SUBJECT: Indian Point Unit No. 2 Spent Fuel Pool Storage Capacity Increase
(TAC 72962)

ADDITIONAL INFORMATION REGARDING THE INDIAN POINT 2
INCREASE IN SPENT FUEL POOL STORAGE CAPACITY
(RESPONSES TO REFERENCE 1)

CONSOLIDATED EDISON COMPANY OF NEW YORK, INC.
INDIAN POINT UNIT NO. 2
DOCKET NO. 50-247
JANUARY, 1990

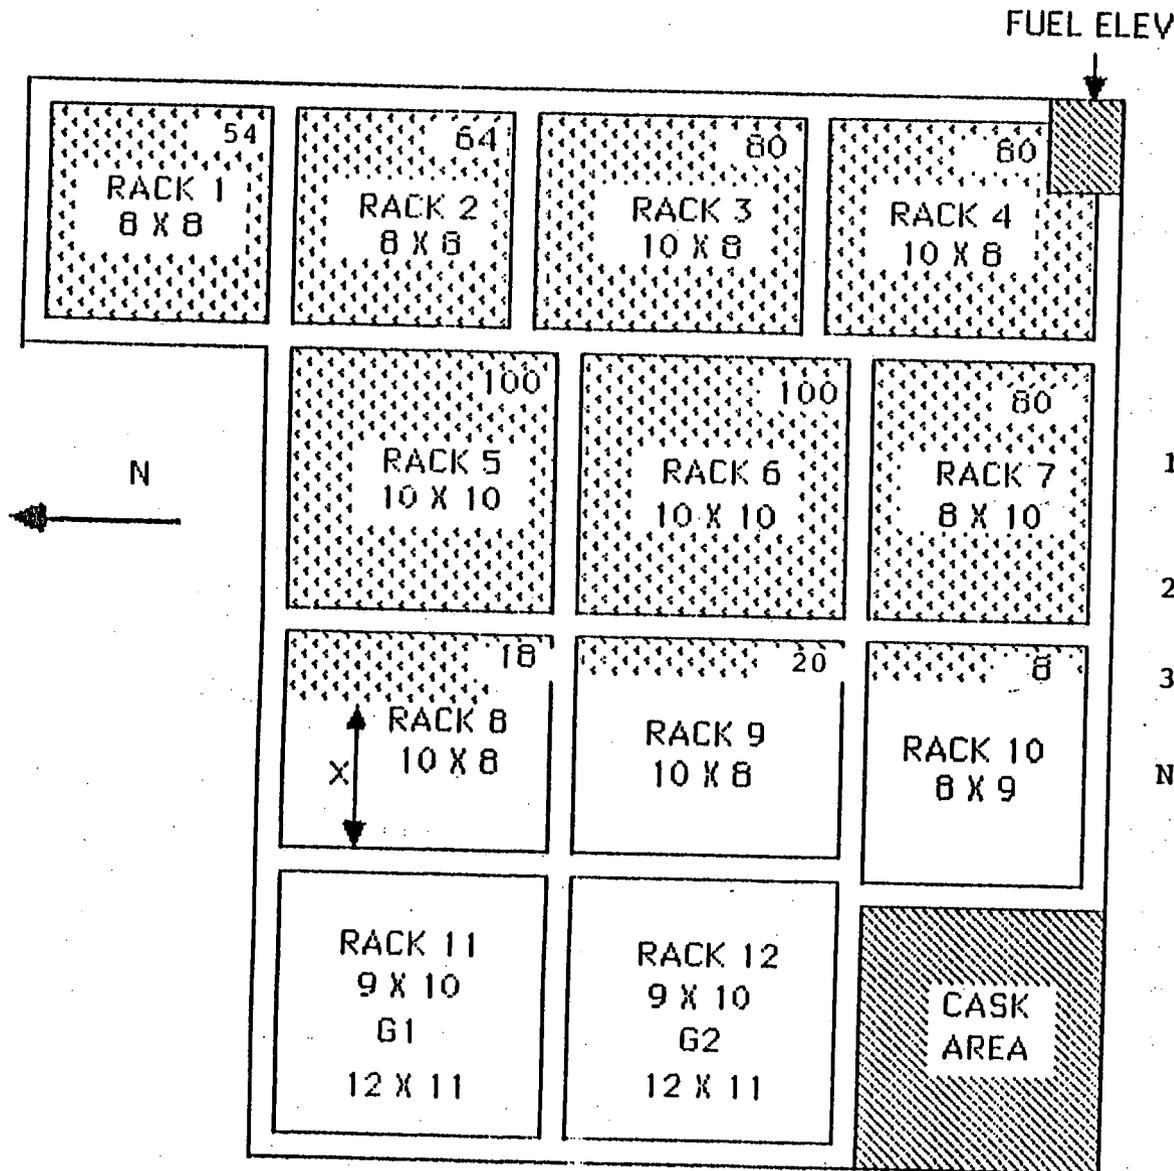
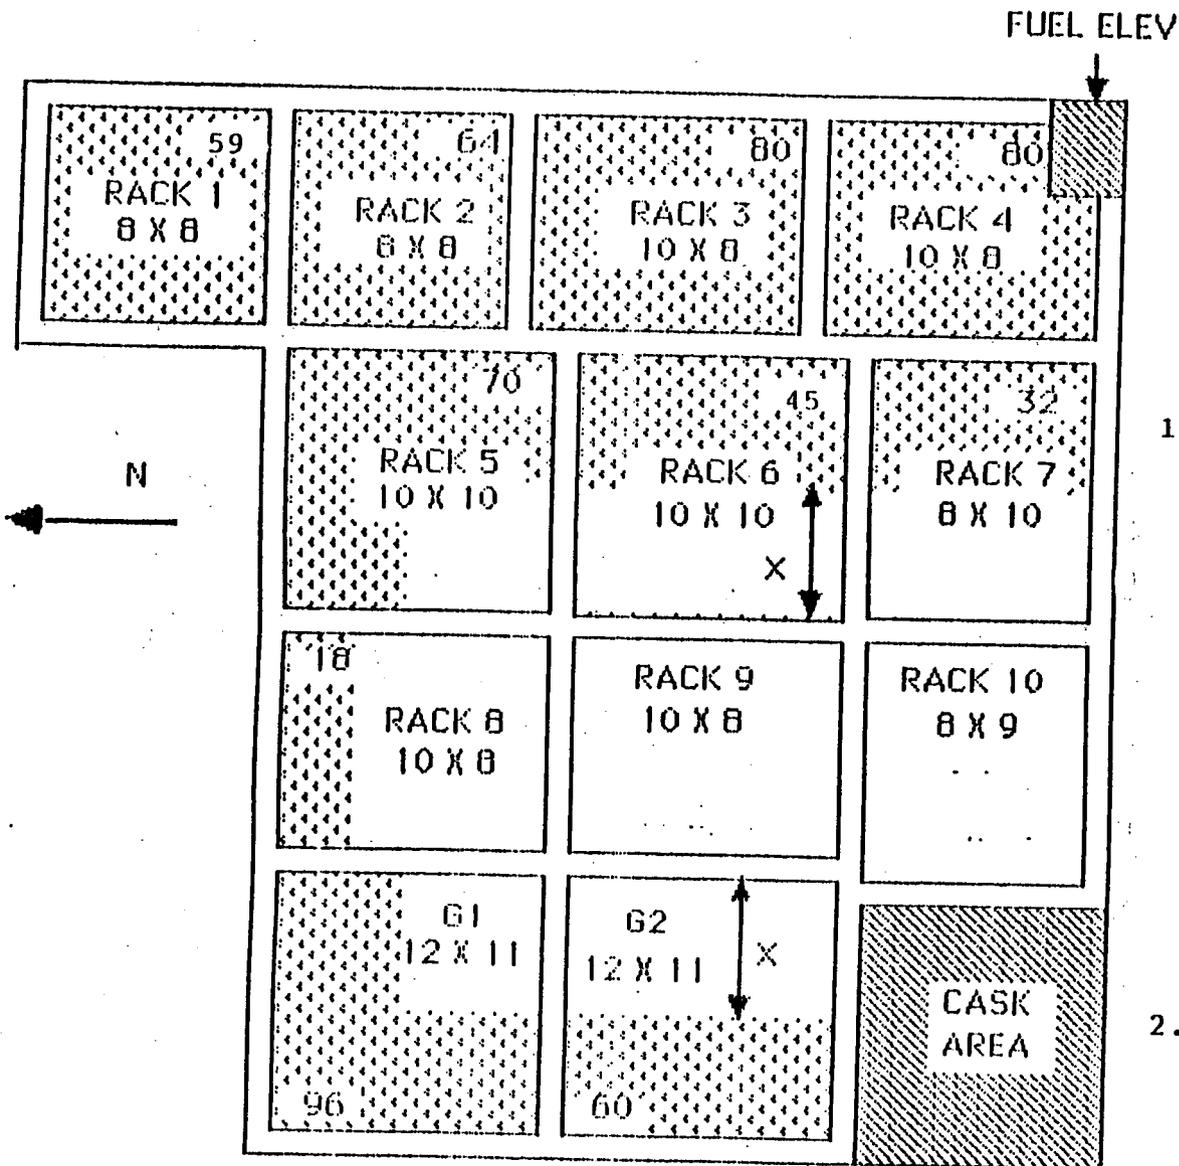
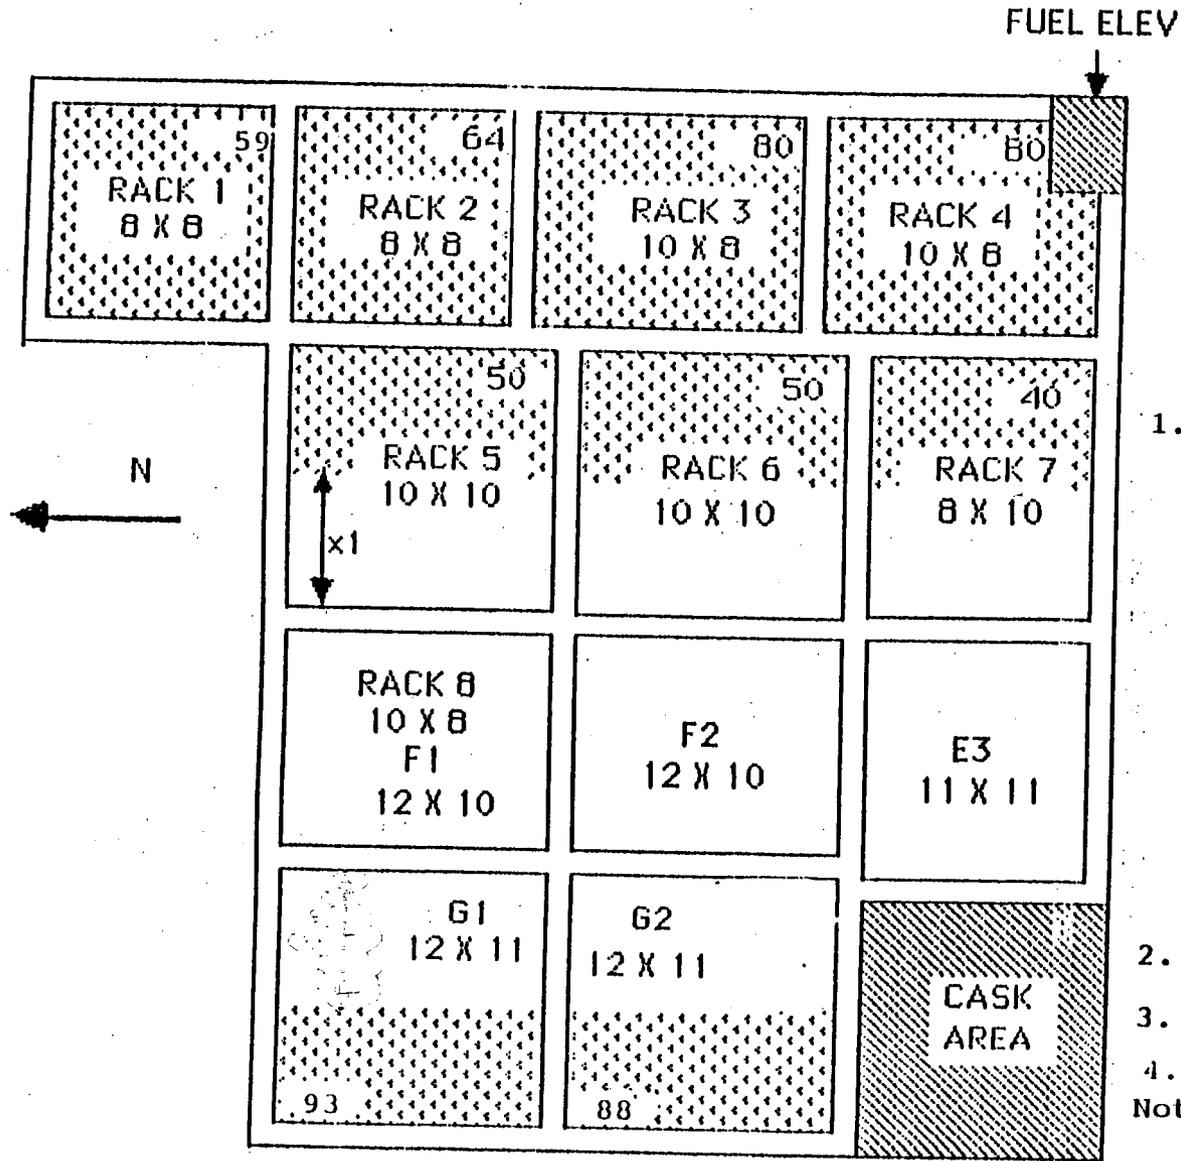
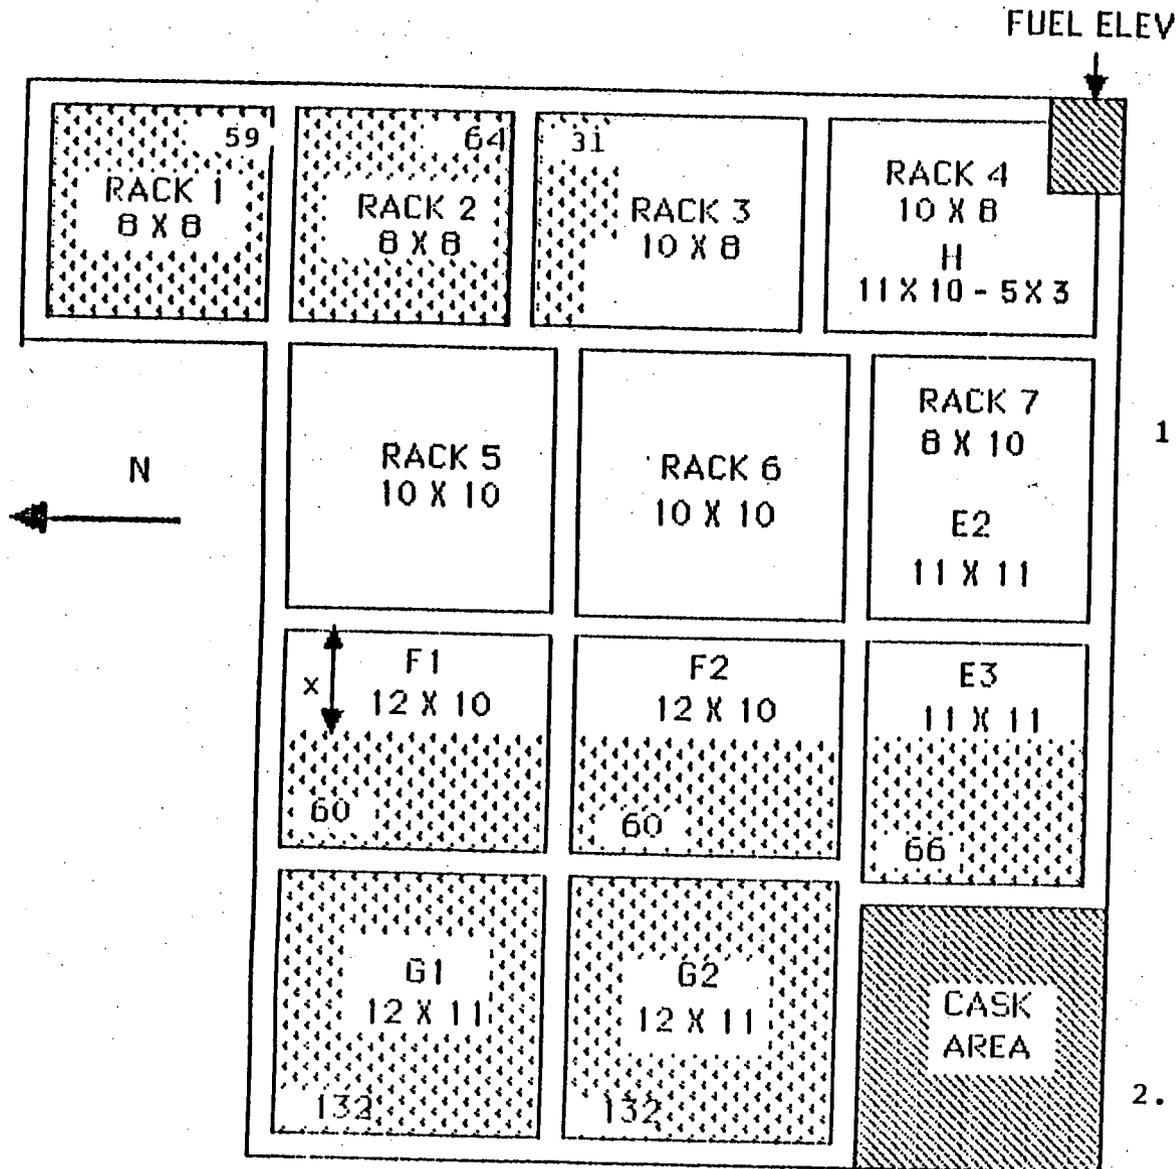
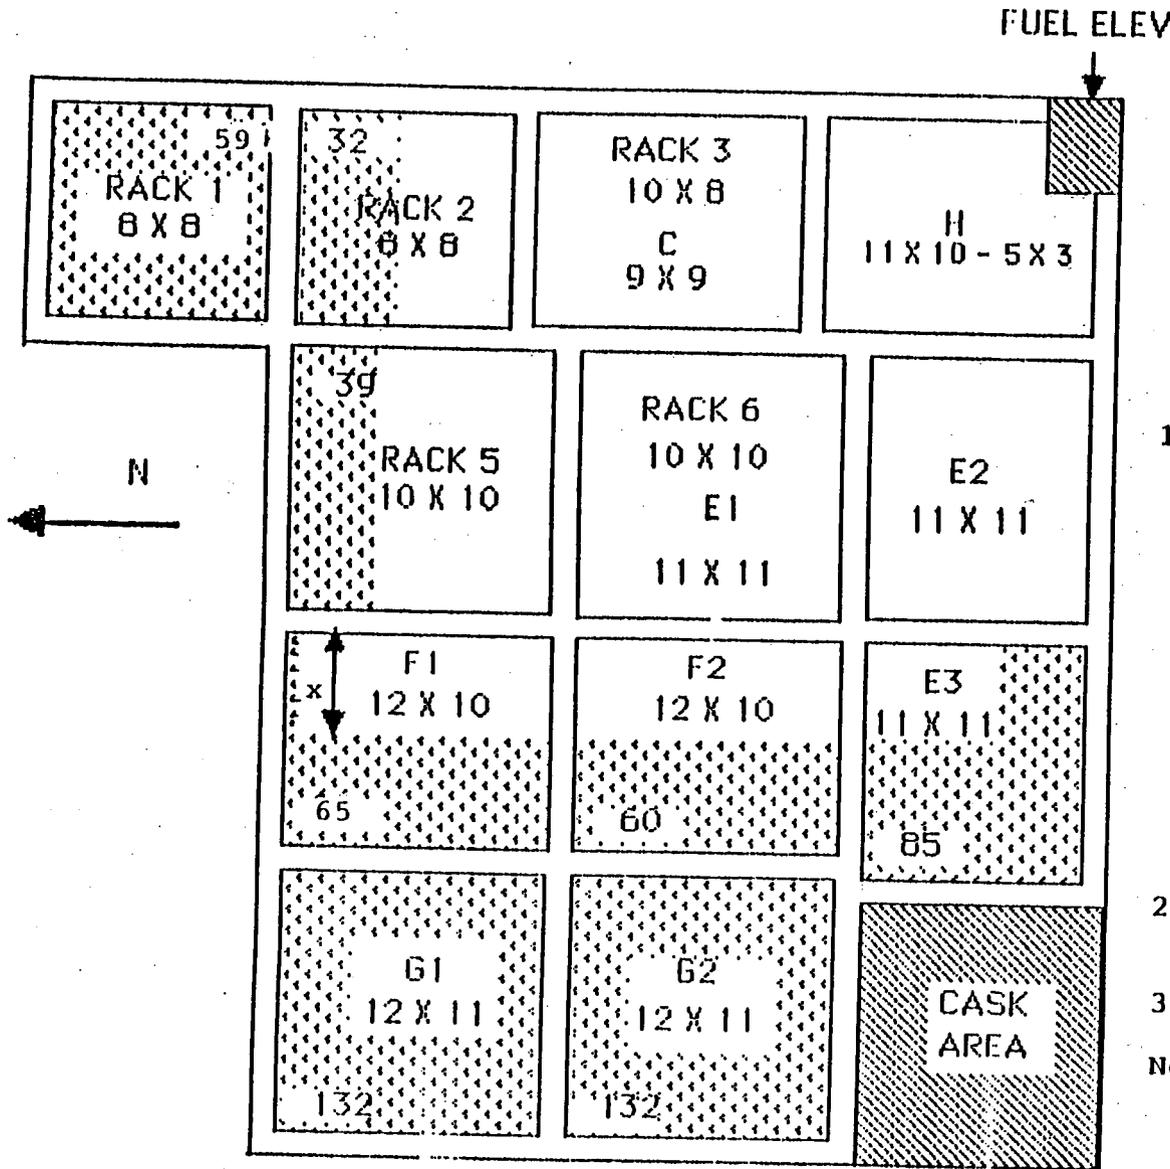
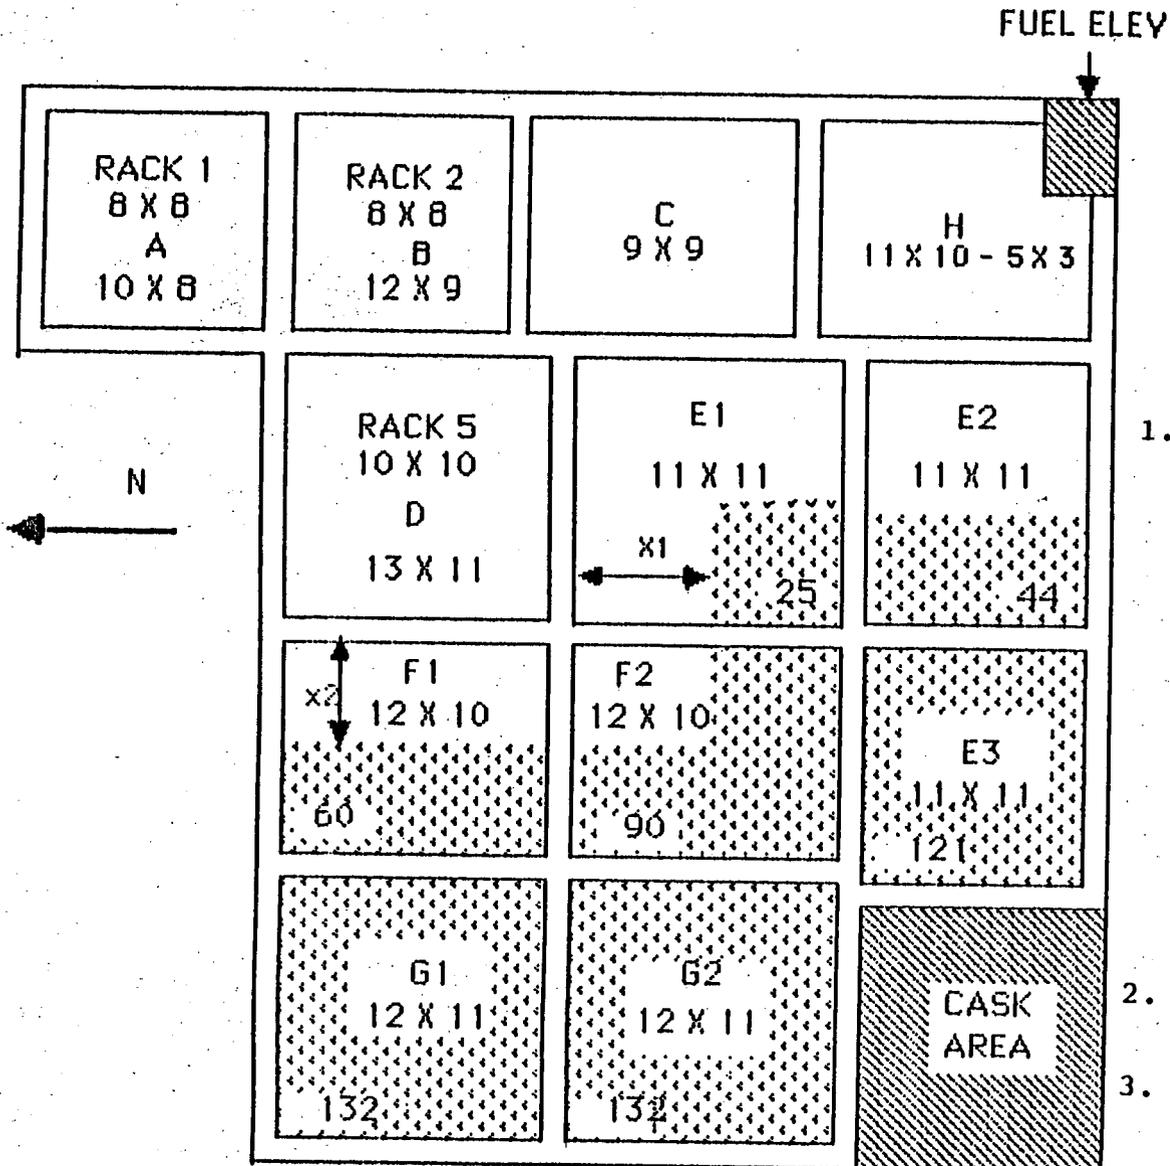
Question 2. Provide an outline of the procedure to be used for (1) moving the spent fuel assemblies (SFAs) already in the pool, (2) removal of the old spent fuel storage racks, (3) installation of the new racks and (4) replacement of SFAs in new racks. Indicate approximate minimum distances between stored spent fuel and racks during movement.

The removal and installation of the racks involves a carefully planned sequence of fuel assembly relocation followed by old rack removal and new rack placement. Figures 1 through 6 show the sequence of rack regions occupied by fuel, racks removed and racks installed in the pool. Old racks are indicated by numerals 1 through 12. New racks are designated by alphanumeric identifications used in the Licensing Report. The dimension "x" (with subscripts where necessary) indicates the shortest distance between the fuel and the new racks at each reracking stage. These figures provide proposed fuel shuffles which meet the objective of maintaining a minimum distance of four feet between stored fuel and a rack being installed. The final reshuffling plan may differ somewhat from Figures 1 through 6, but the objective of maintaining the minimum distance of four feet will be met.

- 4) Replacement of SFAs in new rack:
- o The SFAs will be placed into the new racks as required by the fuel shuffles shown in Figures 1-6 in accordance with the fuel movement procedure outlined in item 1 above.
